# ALOFT AeroArchitects CUSTOMER SERVICE NEWSLETTER

**ALOFT AeroArchitects** offers a number of Product Improvements for the PATS Aircraft, LLC Auxiliary Fuel System. Following are details on several Product Improvement Service Bulletins which are available for installation on your aircraft. We hope you find these articles informative and an aid to your 2016 / 2017 maintenance planning. Please contact ALOFT AeroArchitects Customer Service with any questions or for SB Kit pricing.

### PRODUCT IMPROVEMENT MODIFICATION TO AUXILIARY FUEL SYSTEM RS-422 DATA WIRING BETWEEN THE CAPTAIN P1-1 DISPLAY UNIT AND THE FIRST OFFICER P3-3 DISPLAY UNIT.

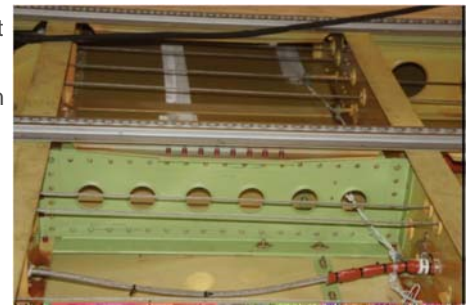
These Service Bulletins are a product improvement for the B737-700IGW/-800 which modifies the RS-422 data wiring between the Captain's Auxiliary Fuel System (AFS) display unit (DU) located on the P1-1 panel and the First Officer's DU located on the P3-3 panel. The Auxiliary Fuel System, installed by PATS Aircraft, under STC's ST00936NY and ST01384NY, included RS-422 data supplied from the Auxiliary Fuel Control Unit (AFCU) to each of the flight deck DUs. Redundant data was also installed from the Captain's DU to the First Officer's DU. Accomplishment of this SB is recommended to eliminate the redundant supply of RS-422 data to the First Officer display unit which has been noted to cause display flickering on some aircraft.

These Service Bulletins provide the instructions to modify (cap and stow) the existing RS-422 data wiring between the Captain and First Officer display units.
